## APPLICATION REVIEW - DRAINAGE

Edgewater Hill Development; MS-2 Building

June 23, 2020

RE: **Edgewater Hill Development; MS-2 Building  
Additional Town Engineer Review Comment Response**

*Pre-Development Conditions*

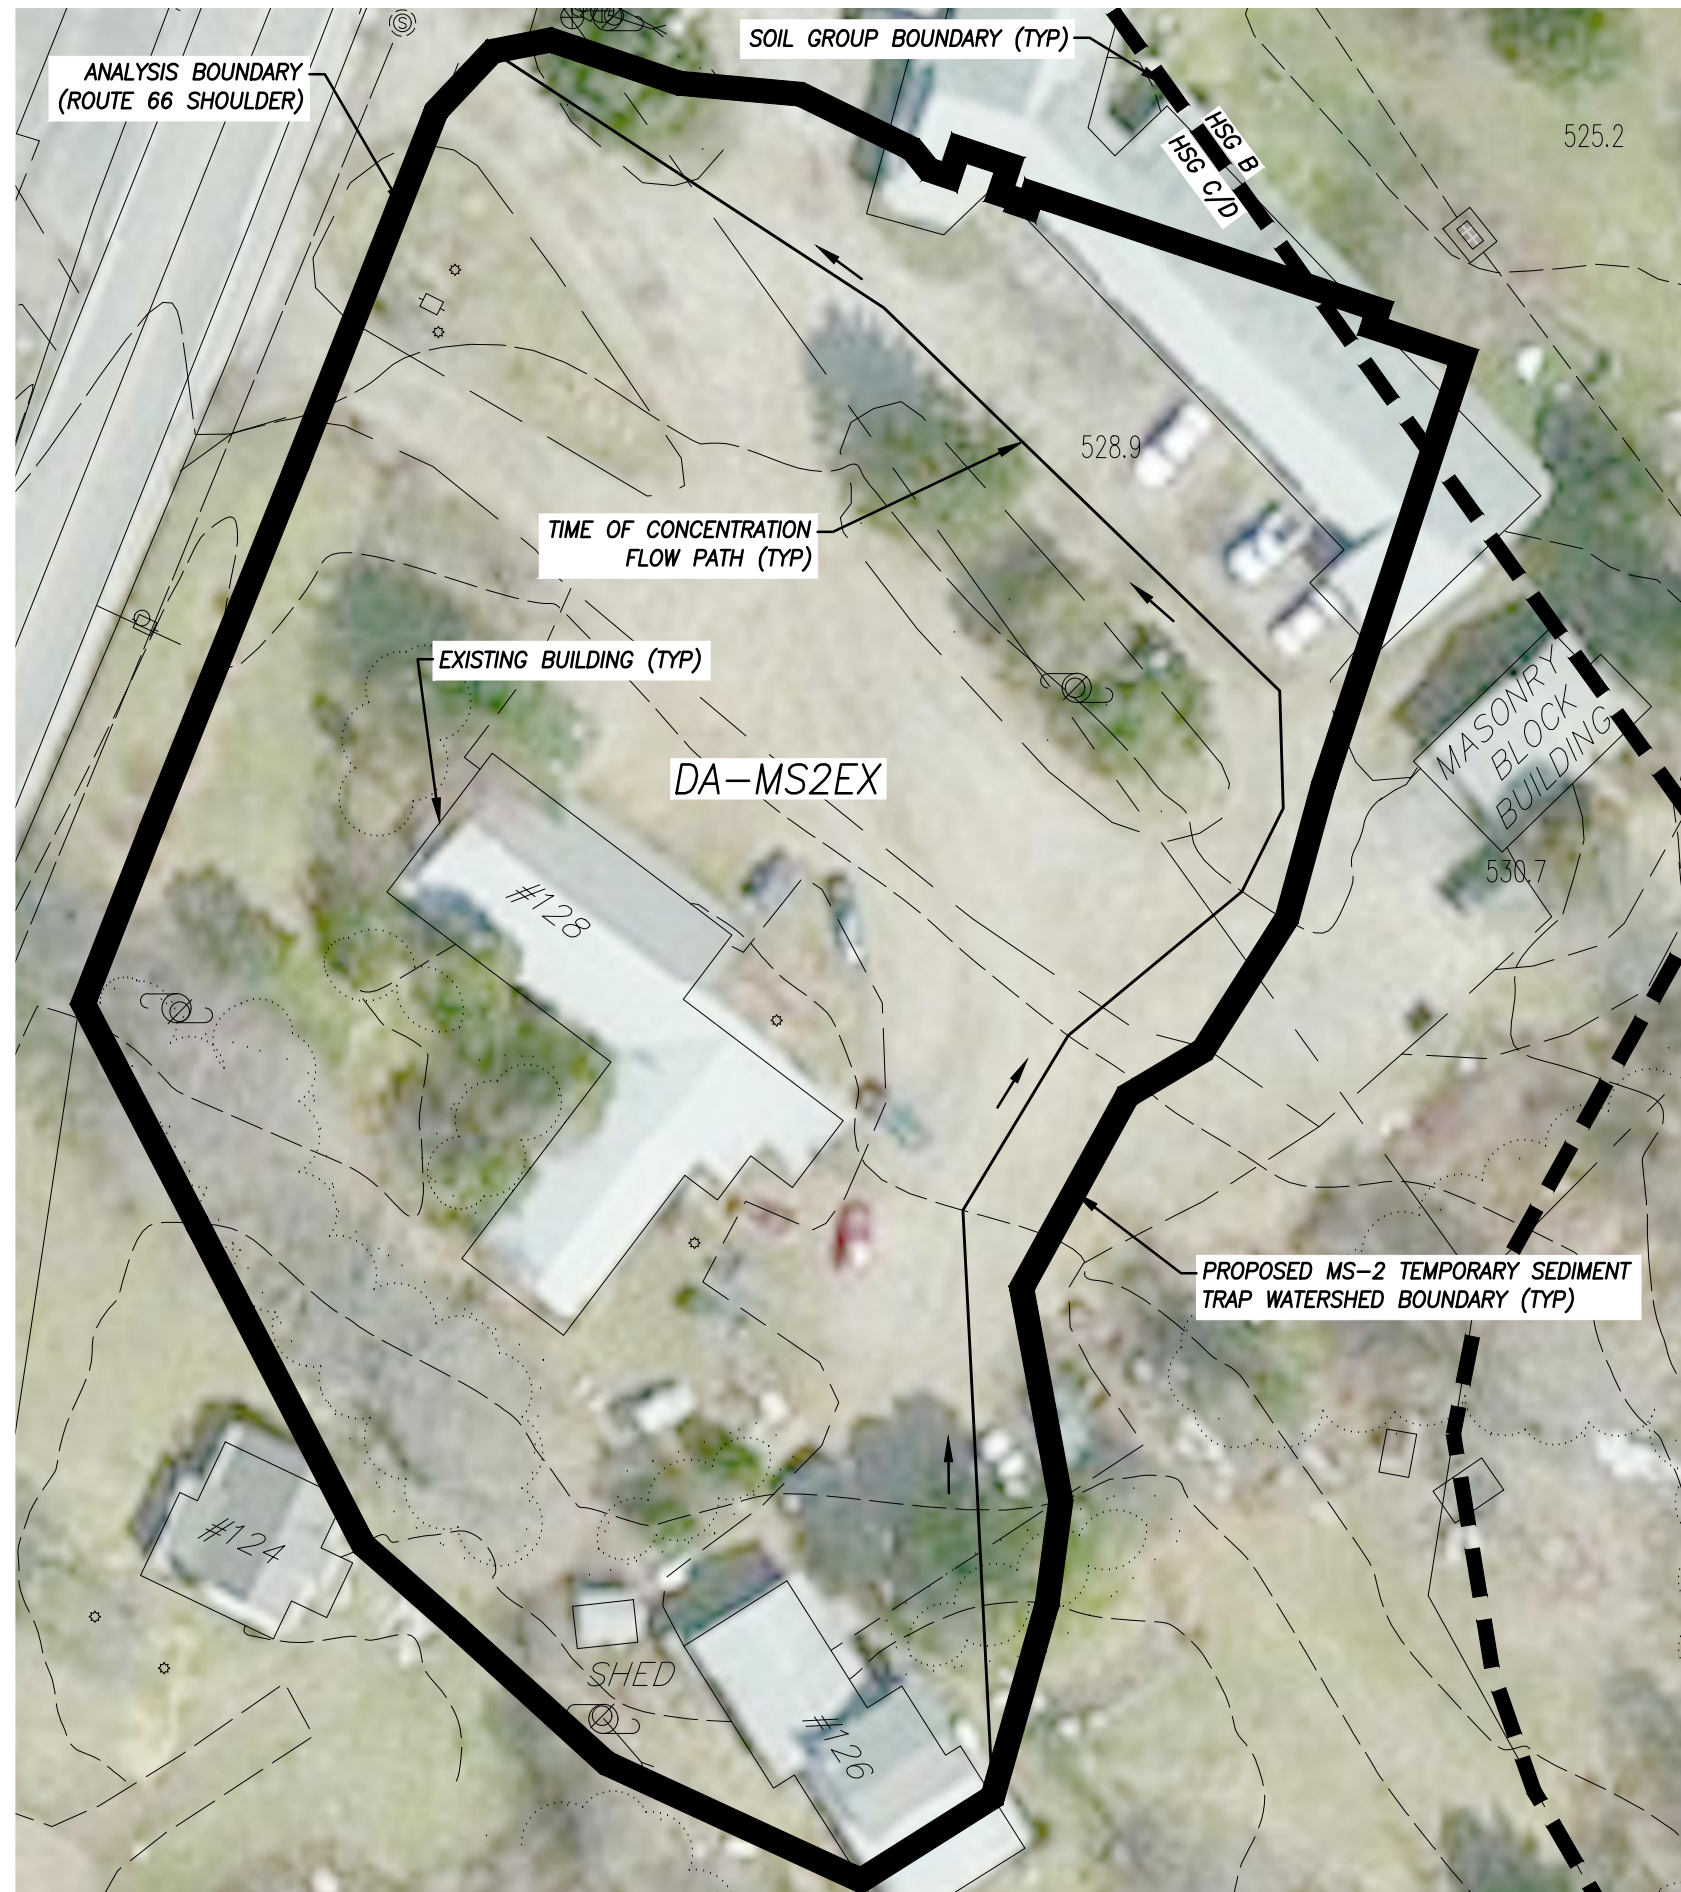
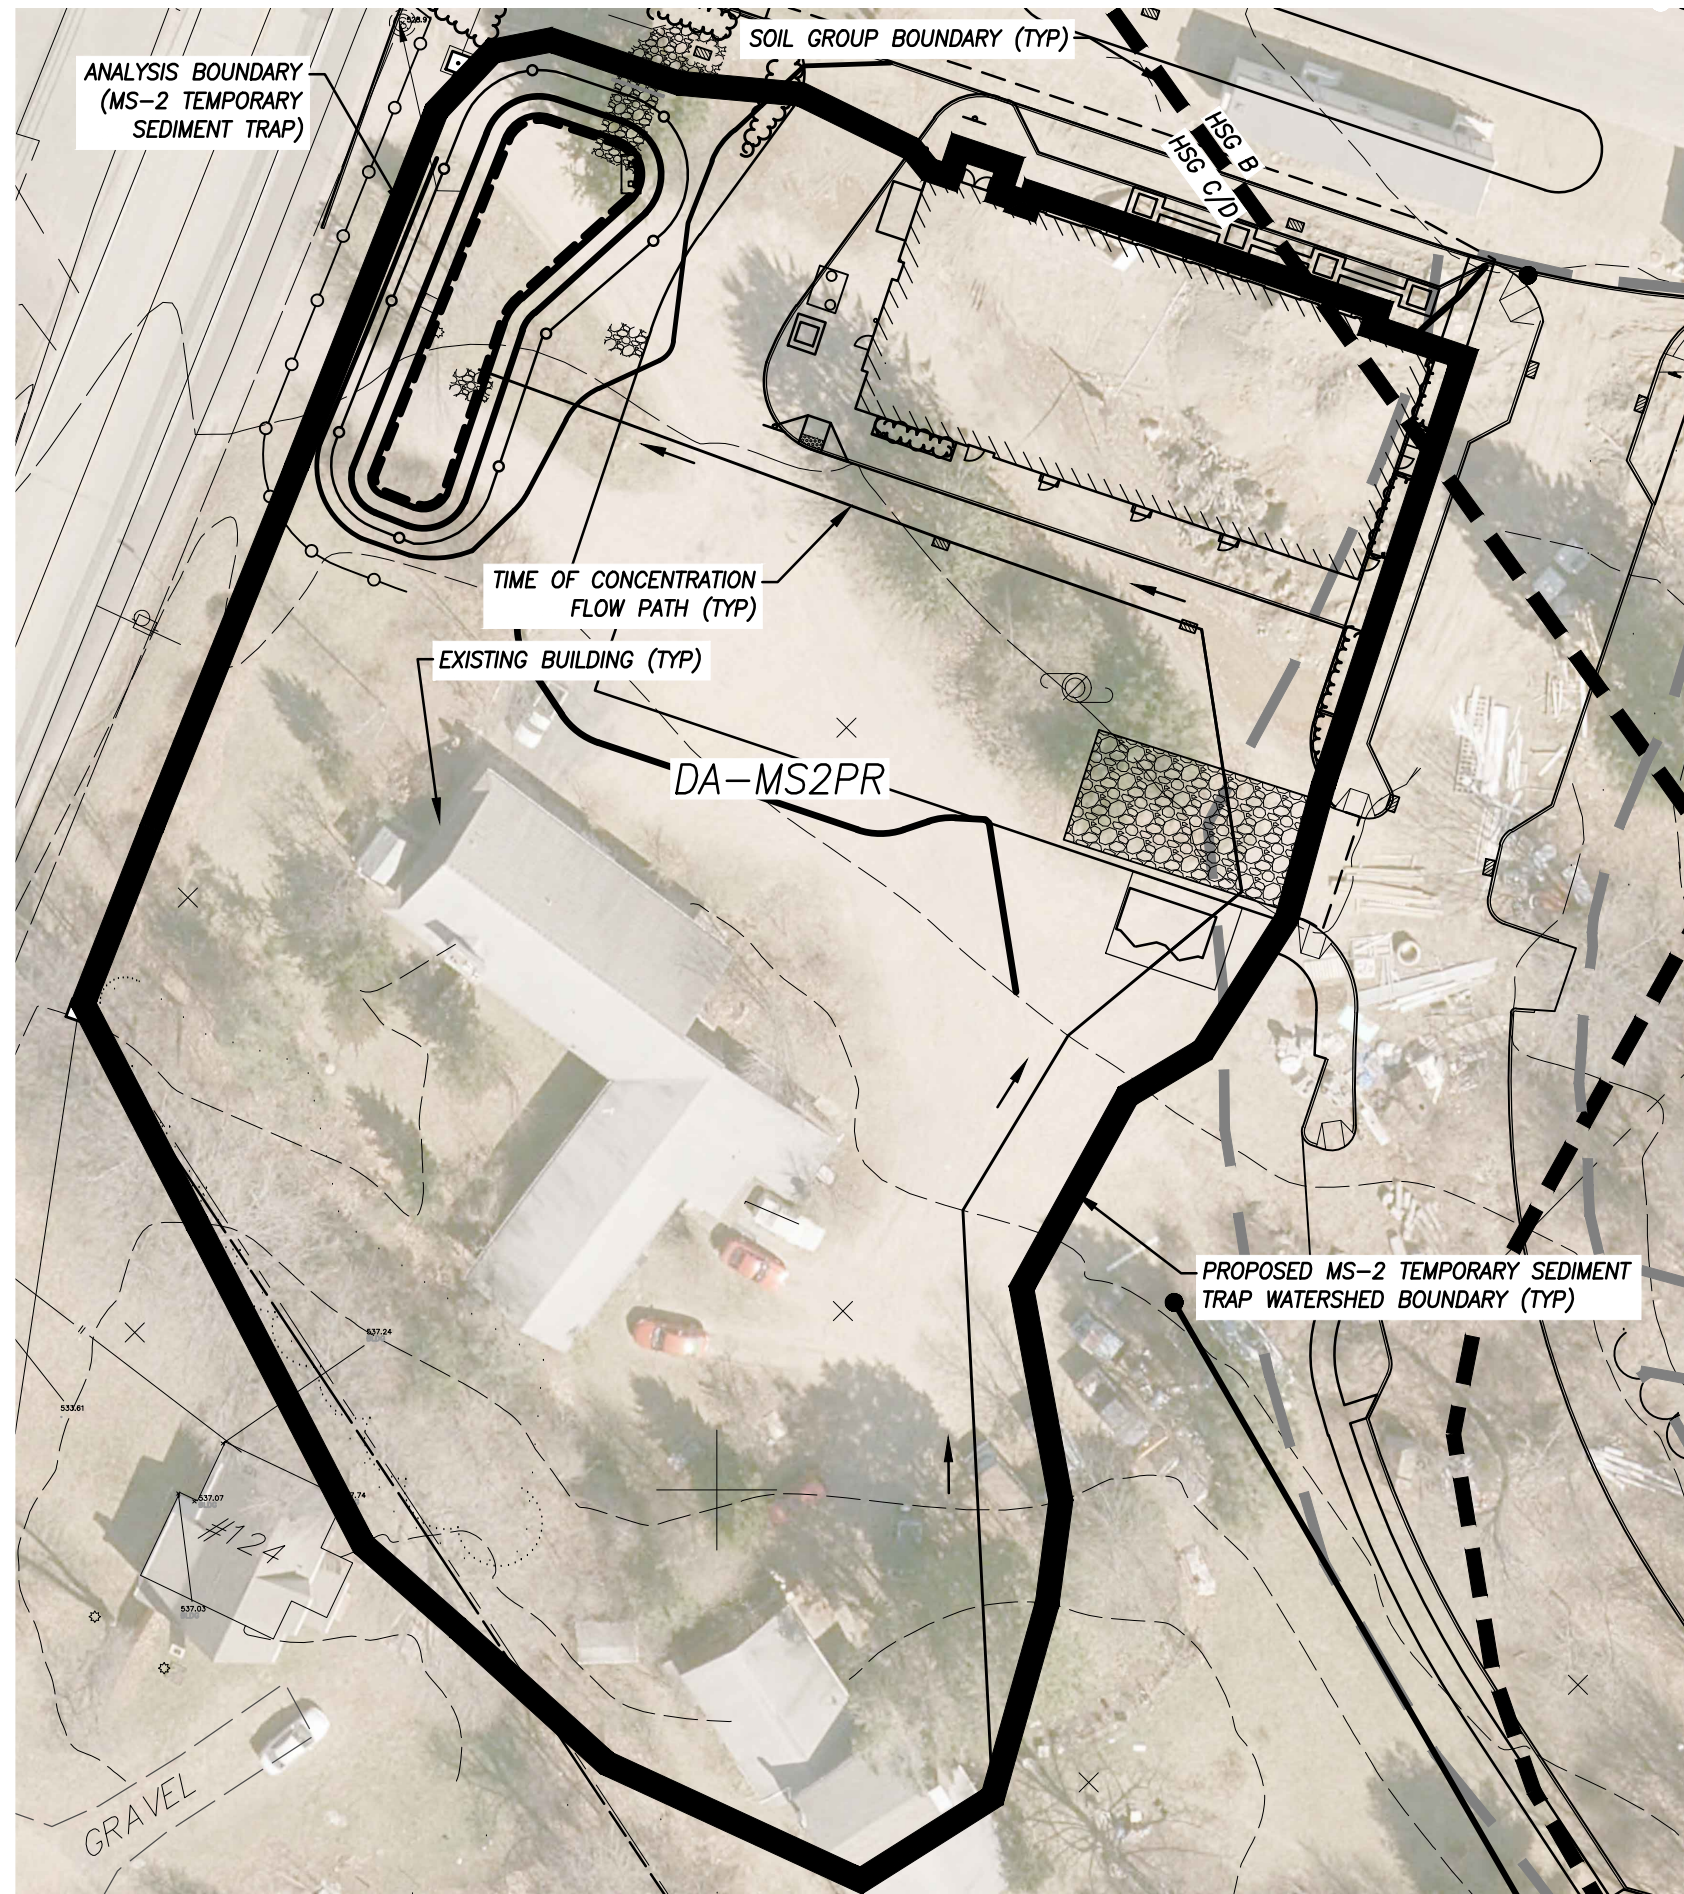
1. The future stormwater quality basin is proposed to be much larger than the temporary sediment trap included on the plans and the analysis includes the full build out. An analysis should be run to confirm that the smaller basin as included with the MS-2 building is adequate for the current proposed conditions (MS-2 only).
  - a. The 1.546 acre area that contributes runoff to the MS-2 temporary sediment trap was evaluated for both pre-development and post-development conditions. The CN value of 87 is the same for both conditions as the proposed impervious area for the MS-2 building and associated parking area is roughly equivalent to the former motel and associated parking areas. Also, some gravel surfaces will be replaced with grassed areas as part of the MS-2 development. Pre- and post-development peak runoff rates of the contributing watershed are compared in Table 1.

As demonstrated in Table 1, post-development peak runoff rates are less than pre-development rates under all modeled design storms. Watershed delineation figures are attached to this letter along with pre- and post-development conditions modeling results. Water quality volume calculations for the temporary sediment trap and the MS-2 building are included in the original Stormwater Management Report. The storage available below the lowest above-grade outlet orifice is greater than the calculated water quality volume for the MS-2 development.
